Agenda Item # 9C

Note: Please include these comments in the Public Administrative Record for the Syar EIR.

Susanne von Rosenberg
Verbal Comments
Planning Commission Hearing 10-21-2015
Syar EIR/Permit

Letter V Response to Comments**Comment V-1**

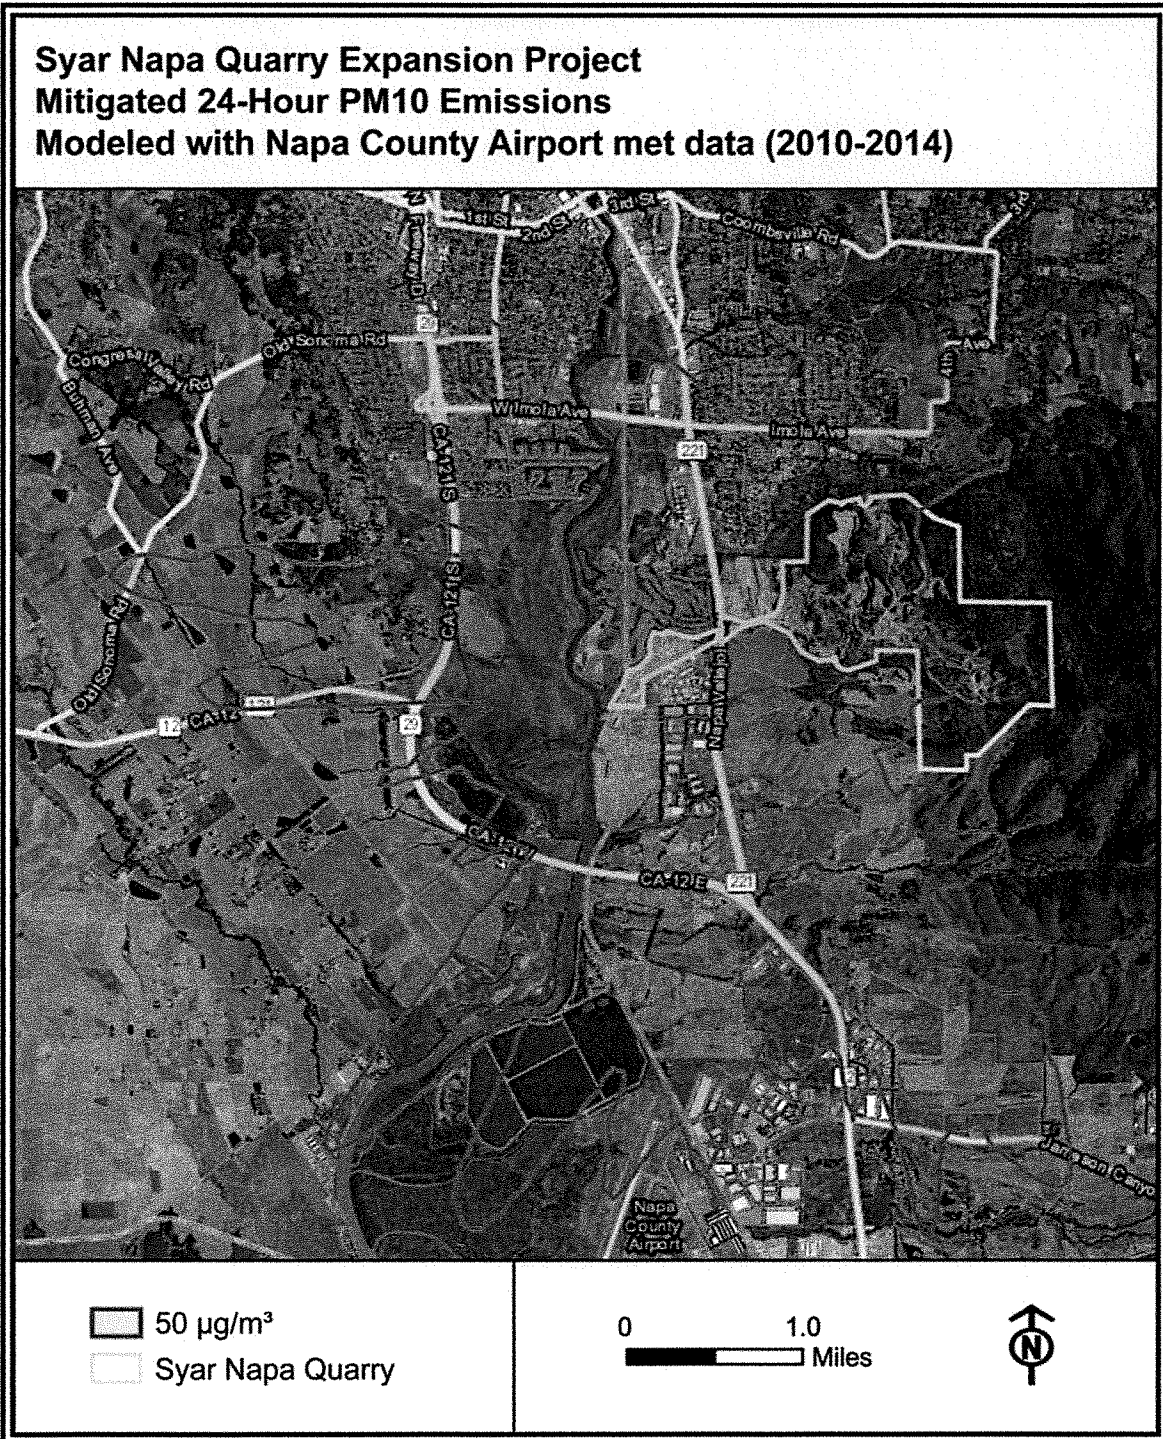
The following map illustrates the modeled area in violation of the CAAQS. To create the map, I generated an isopleth depicting the area in violation of the CAAQS, with 24-hour PM₁₀ concentrations equaling or exceeding 50 µg/m³, using Golden Software, Inc.'s Surfer Version 10. I exported the isopleth as a shapefile and created a map using ESRI's ArcGIS geographic information system (ArcMap v. 10). The isopleth is overlaid on USGS 1-meter orthoimagery obtained from ArcGIS online.

It should be noted that the modeling scenario that I have presented is based on emission rate assumptions made in the EIR, and even so, results are in violation of the CAAQS. The CAAQS levels are never to be equaled or exceeded.

October 26, 2009: This photo was taken from the River Trail behind Napa Valley College. Uncontrolled dust pollution emanating from Syar Napa Quarry is being released into the public air space.

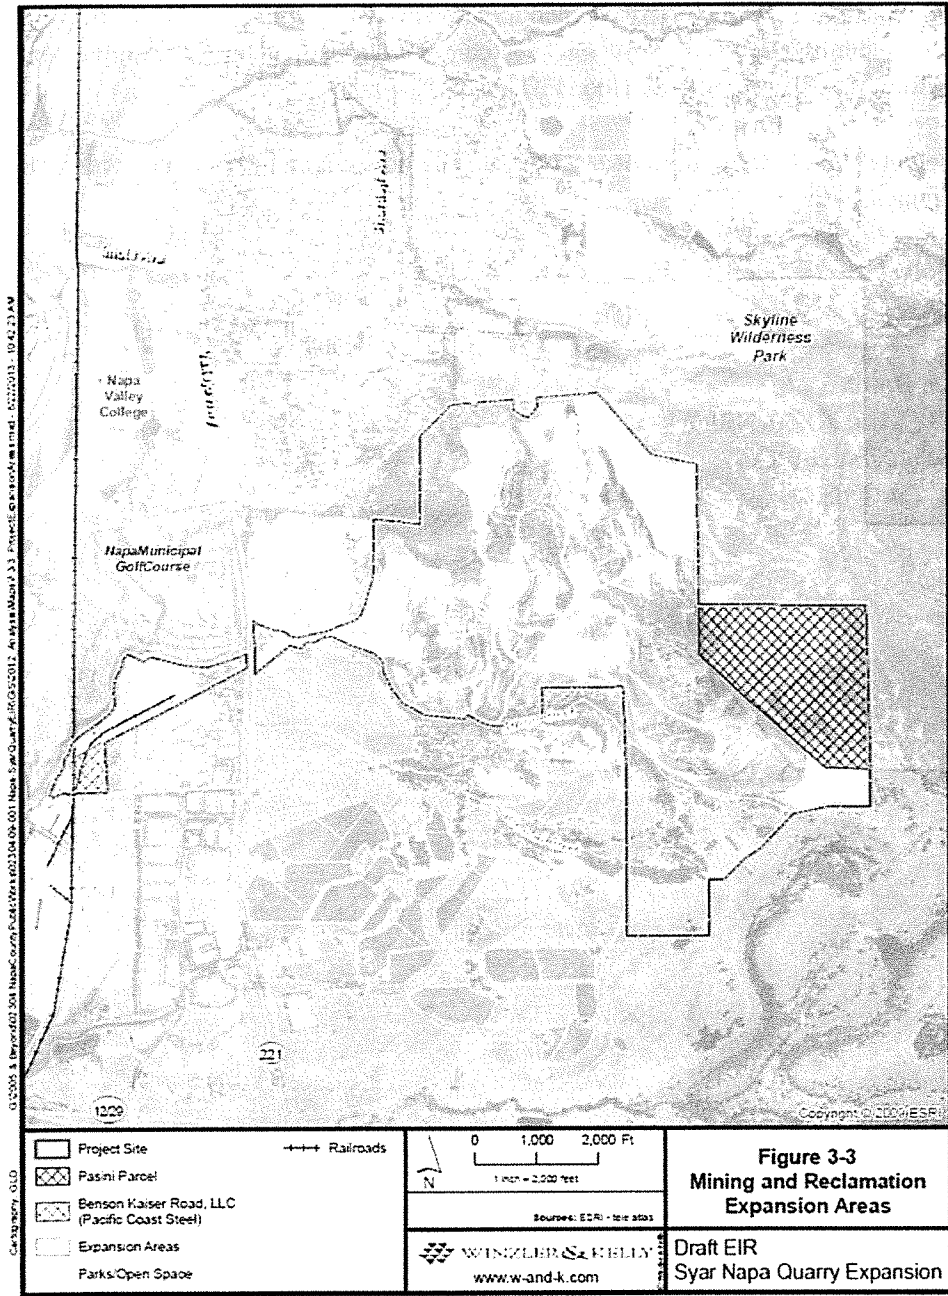
The photographs below are typical of Syar Napa Quarry's uncontrolled, toxic dust pollution. The technology and feasible management practices exist to prevent the quarry's out-of-control, socially and environmentally abusive pollution. It would be helpful to have competent governmental oversight to compel Syar Napa Quarry to implement Mitigation Measure 1, as prescribed in Table 5.3, above.
